## **SMITHCO SUBDIVISION, RESUBDIVISION OF LOT B**

APPLICATION NUMBER 11 DATE May 21, 2009

## DETAIL SITE PLAN

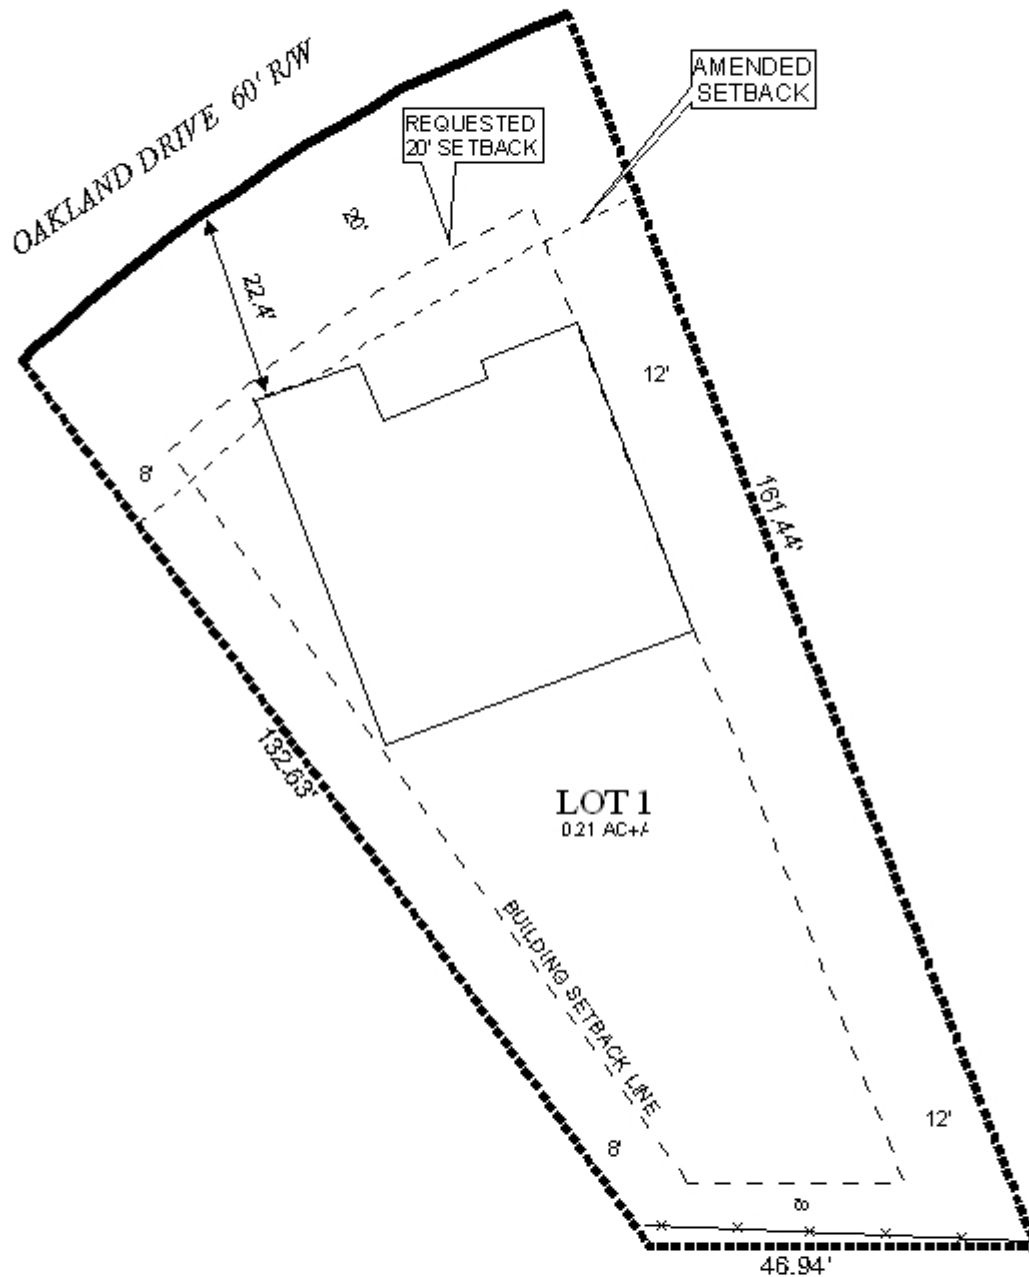
The plat illustrates the proposed 1-lot, 0.2± acre subdivision which is located at the Southeast corner of Oakland Drive, in Council District 6. The subdivision is served by public water and sanitary services.

The purpose of this application is to amend the recorded front building setback line.

Smithco Subdivision was recorded in 2007 as a 3-lot subdivision. In 2008 a building permit was issued for the construction of a single-family dwelling on Lot B meeting the standard recorded 25' front building setback. However, the building footprint was reversed at stake-out resulting in an actual 22.4' front setback at the Northwest corner of the dwelling which was only recently discovered. In order to have the dwelling compliant to the front setback, the applicant wishes to amend the recorded 25' setback to 20'.

In such cases where there is only a slight encroachment into the required setback and the building construction has been completed, modification of the structure to meet the required setback would be impracticable. However, since the encroachment is within 22.4' of the front property line, the amendment of the front setback to allow for the encroachment would be the most practical solution. In conjunction with the amendment of the front setback line on the plat, a Front Setback Variance would be required.

The plat meets the minimum requirements of the Subdivision Regulations and is recommended for Tentative Approval, subject to the following conditions:

- 1) revision of the front setback line to follow the recorded 25' front setback line but amended to follow the footprint of the building within the encroachment; and
- 2) the submission and approval of a Front Setback Variance by the Board of Zoning Adjustment prior to the recording of the final plat.
